LBC comment

Balustrade

Union Terrace Gardens

Appendix 1

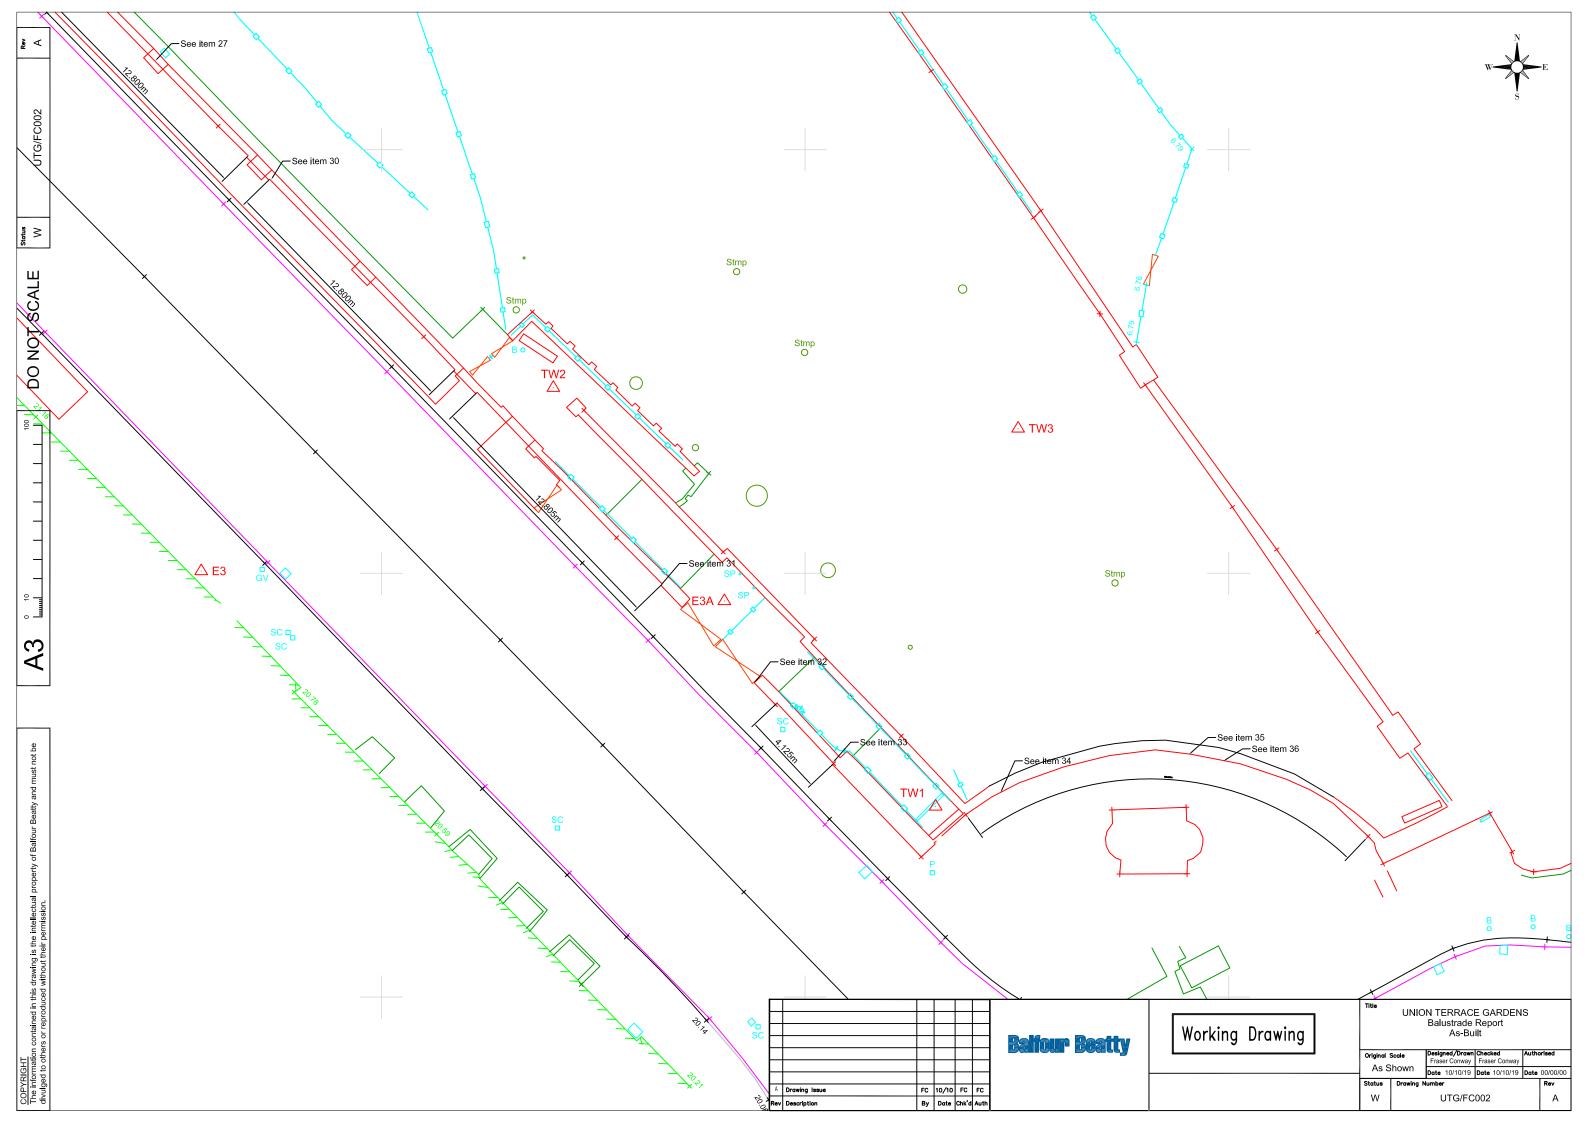
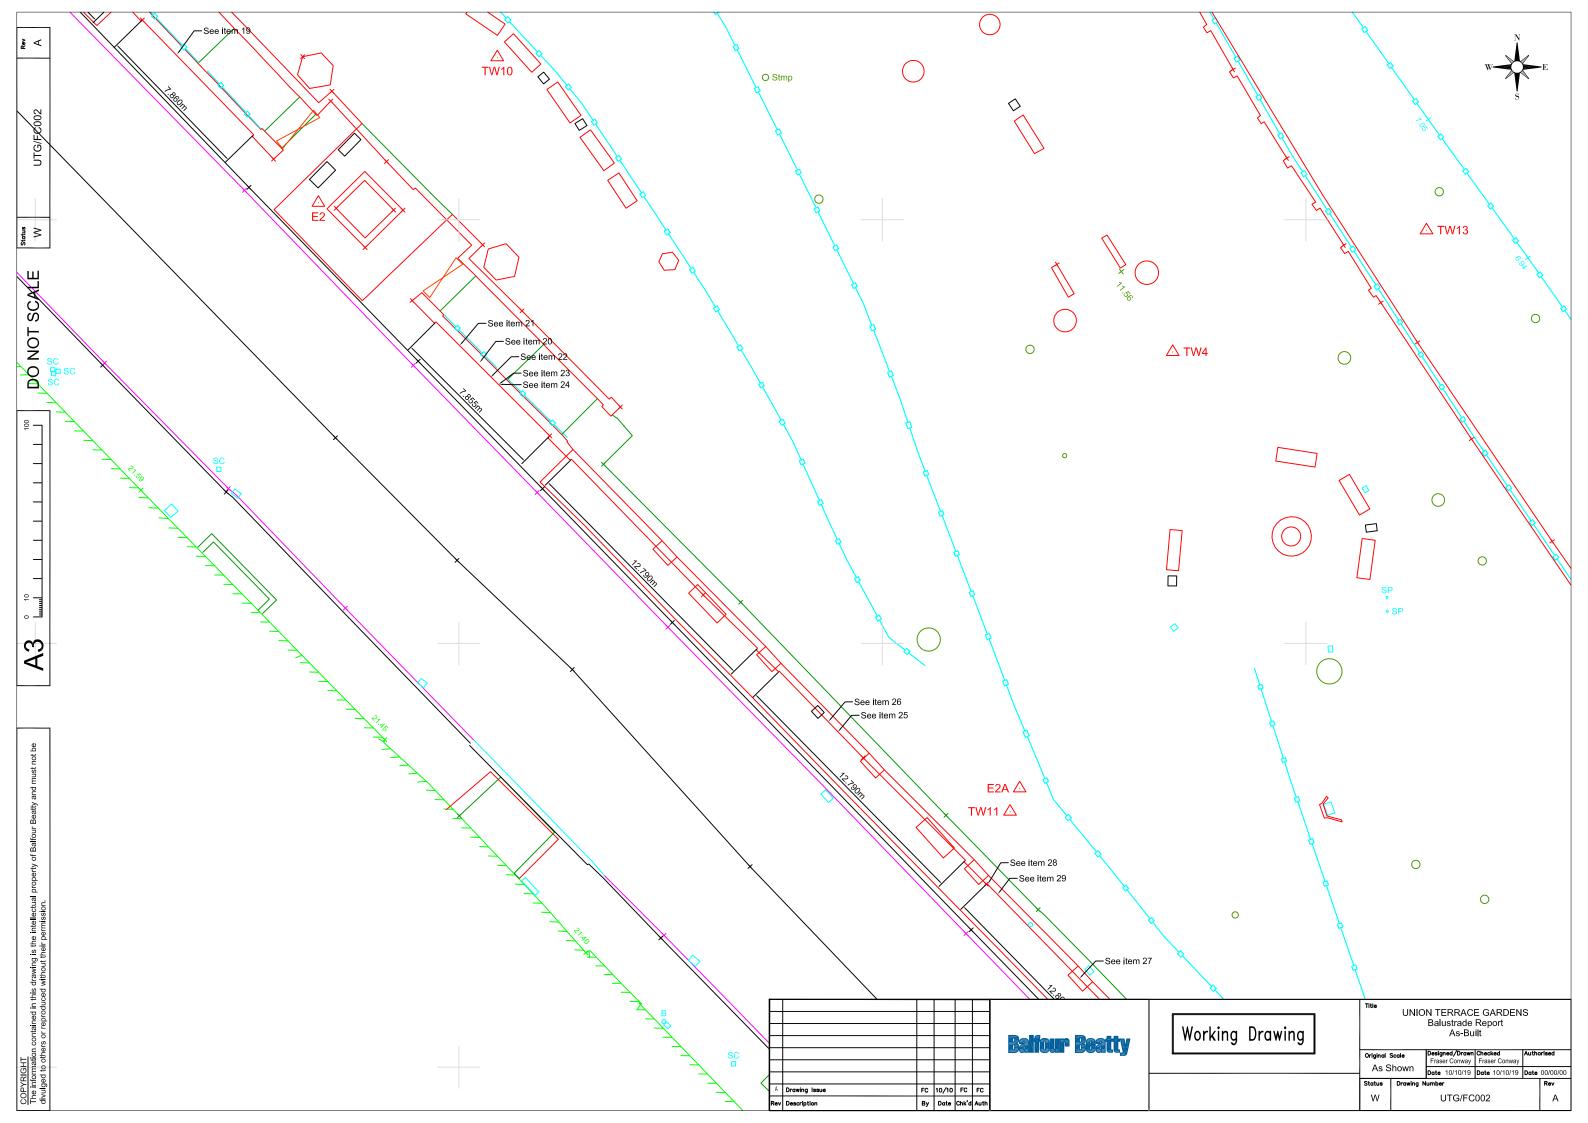
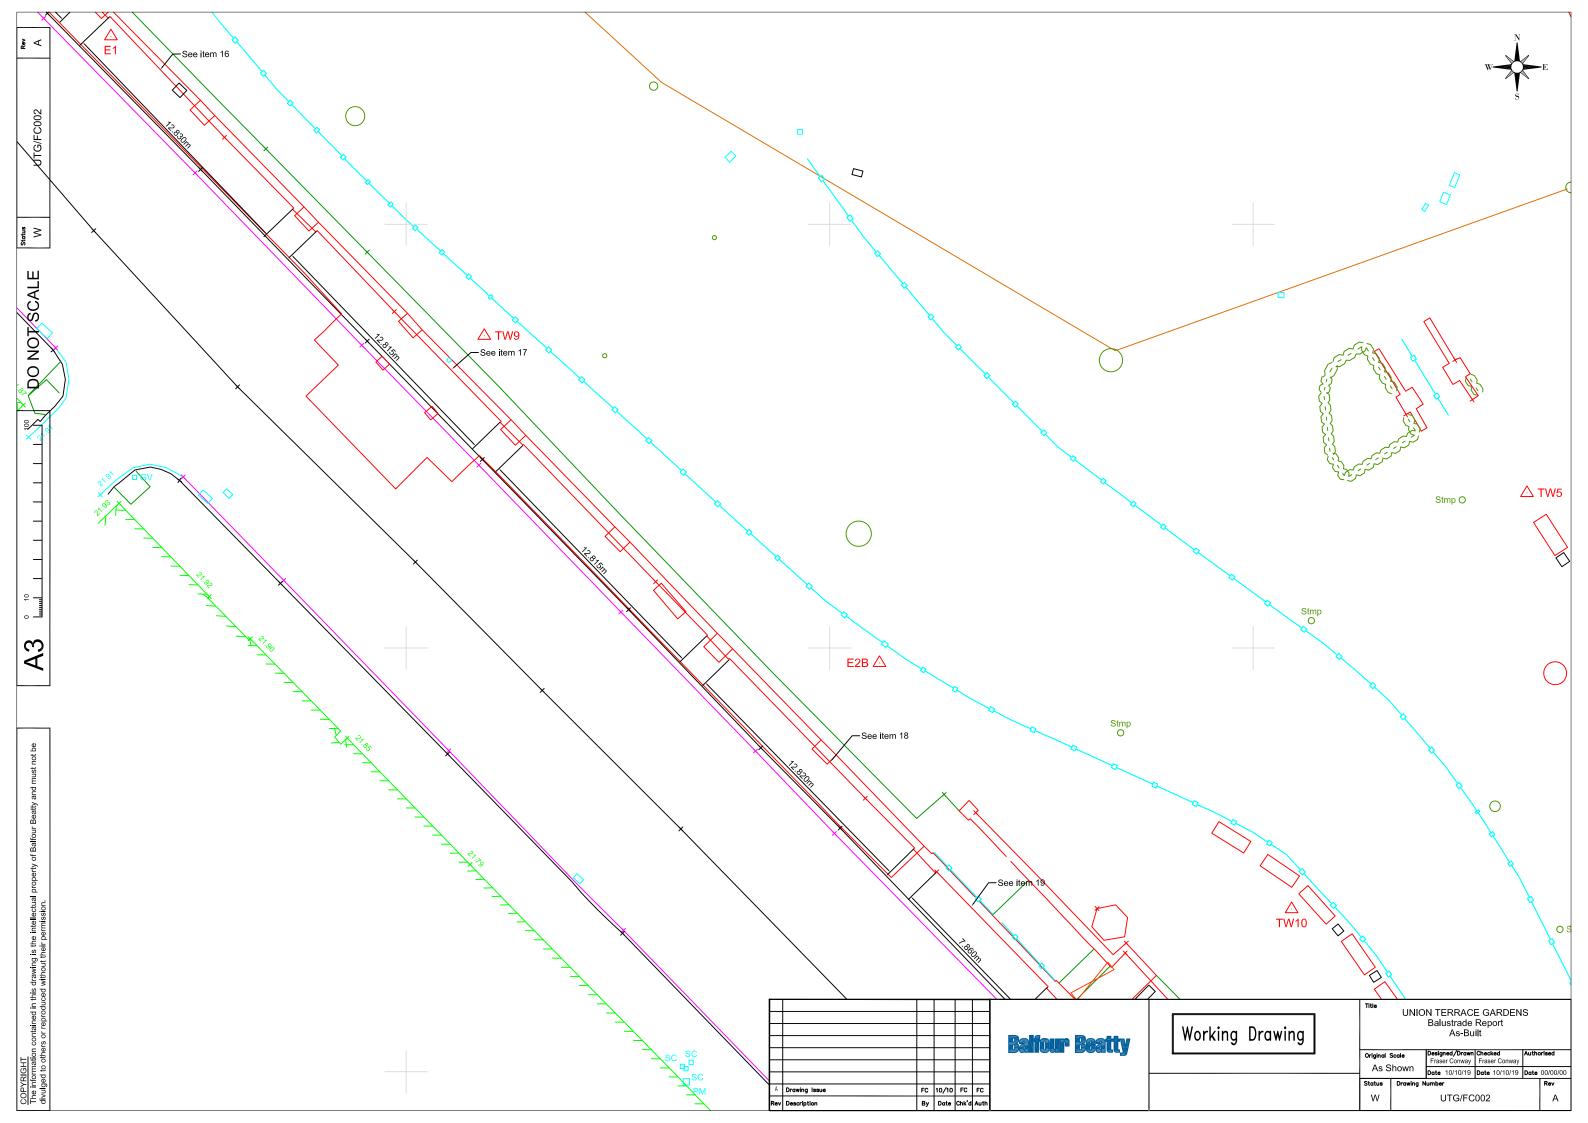
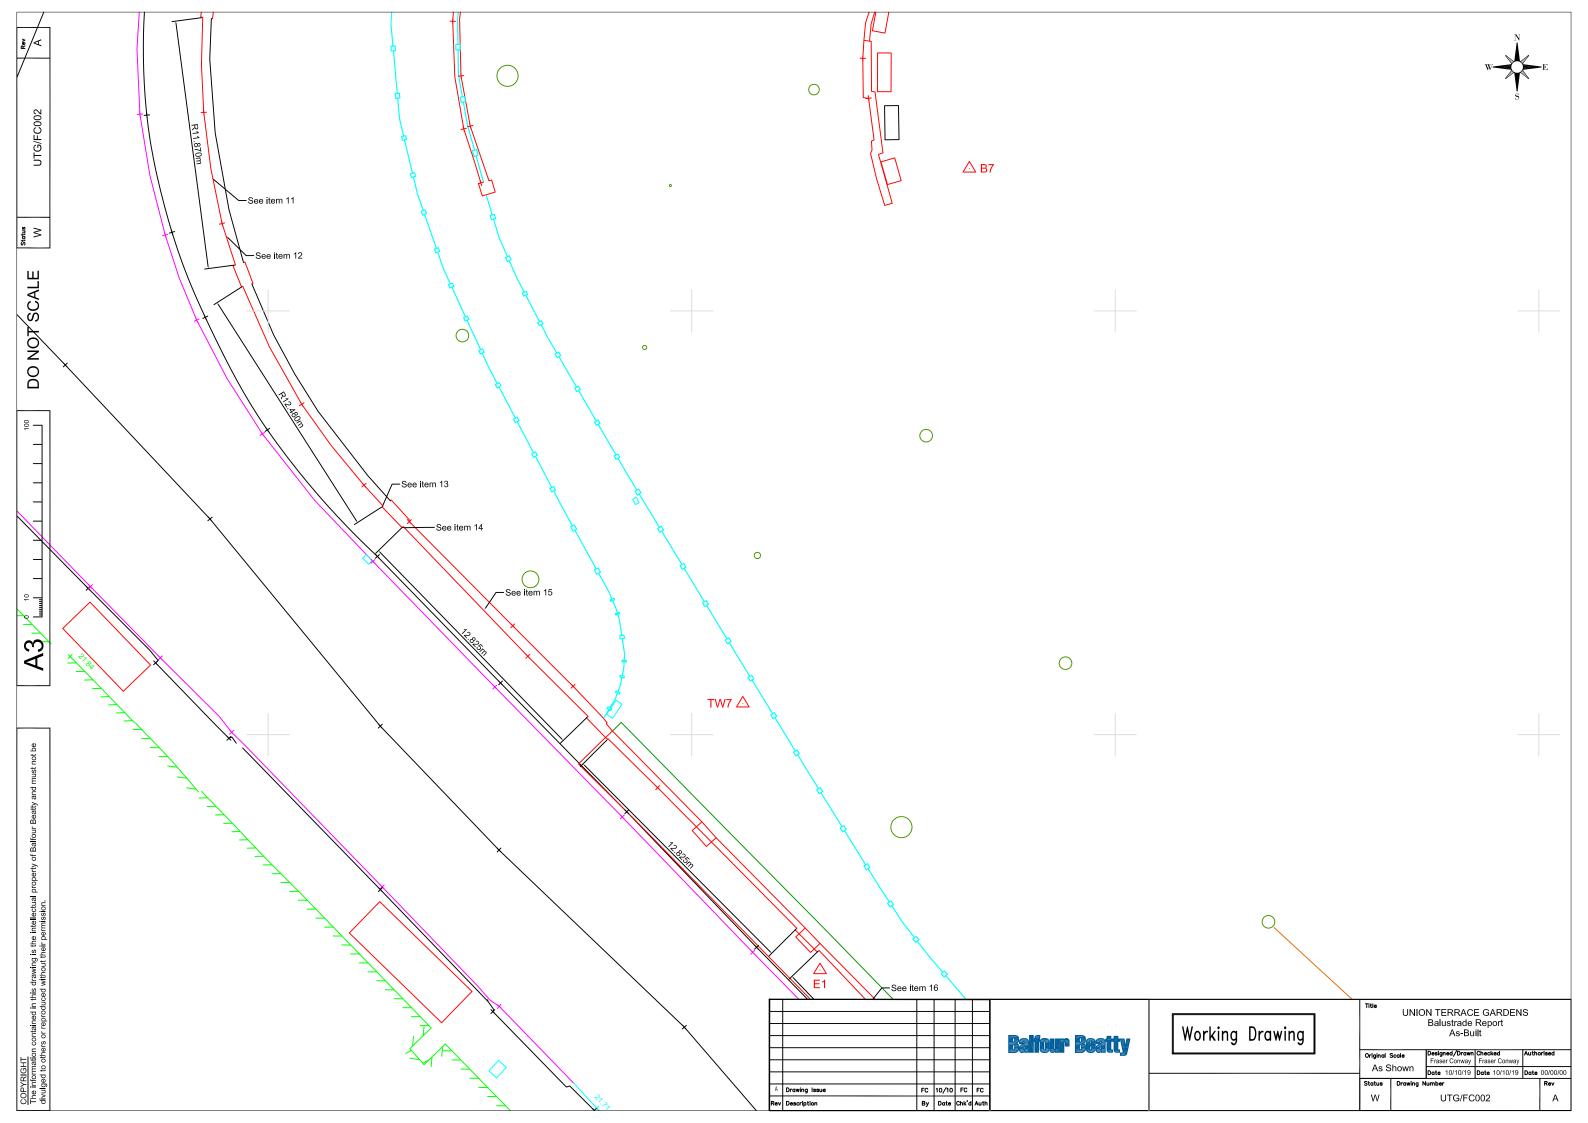
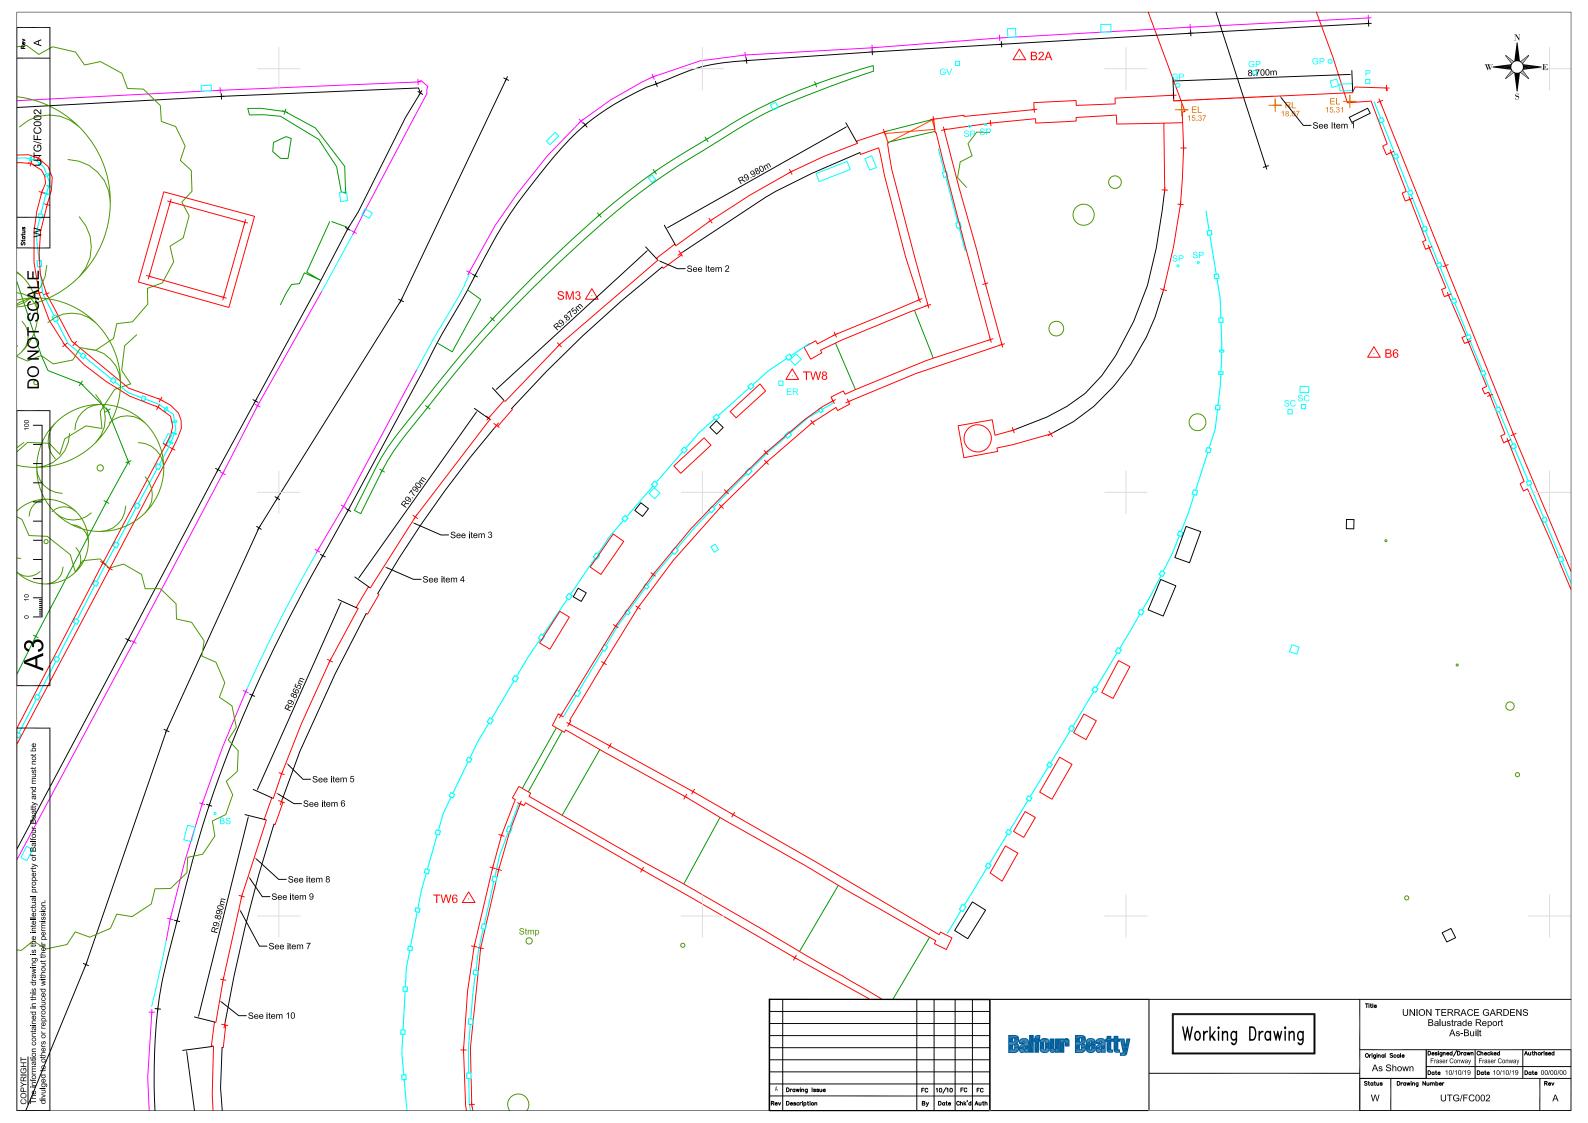
That no works to remove the balustrade around the Gardens at street level shall take place unless a detailed methodology carried out by a qualified specialist for its removal, repair, storage, strengthening and reinstatement have been submitted to and approved in writing by the planning authority. Thereafter no works shall be carried out unless in complete accordance with such details as so approved unless otherwise agreed in writing with the planning authority.

- Before works can start a detailed record of the existing balustrade will be done by BB to high light any existing damages and positions of individual items within the balustrade (see appendix 1).
